October 19, 2015

AEP-NRC-2015-85
10 CFR 50.90

Donald C. Cook Nuclear Plant Unit 2
License Amendment Request Regarding Technical Specification 3.3.2, Engineered
Safety Feature Actuation System (ESFAS) Instrumentation

**Evaluation of Proposed License Amendment Request
Regarding Technical Specification 3.3.2, Engineered Safety Feature Actuation
System Instrumentation**

Figure 1

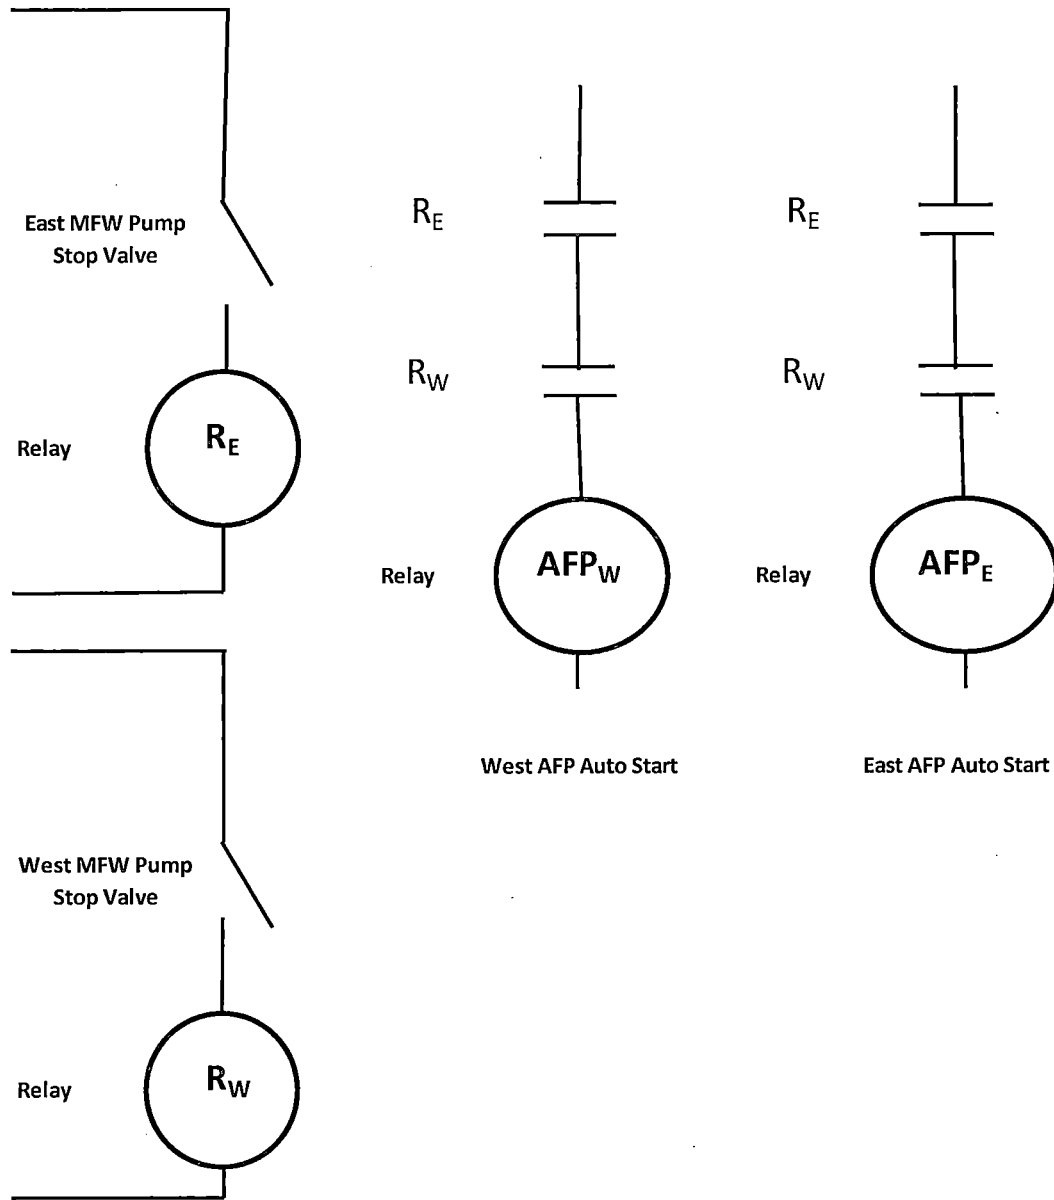
The TS 3.3.2 new Condition H, applies to both anticipatory trip channels. The trip channels are combined using an "AND" logic circuit requiring 2-out-of-2 channels (see Figure 1). Failure of any one of the two (one per MFW pump) channels results in loss of AFW auto-start function. Therefore, the trip channels must be declared OPERABLE within 48 hours of entering Condition H. This Required Action is consistent with the previously applicable Condition B for Function 6.g. To reflect the new Condition, the current Condition H (renumbered to Condition I) will be changed to reflect the new Condition H for Function 6.g. This Condition has a Required Action to be in MODE 3 in 6 hours.
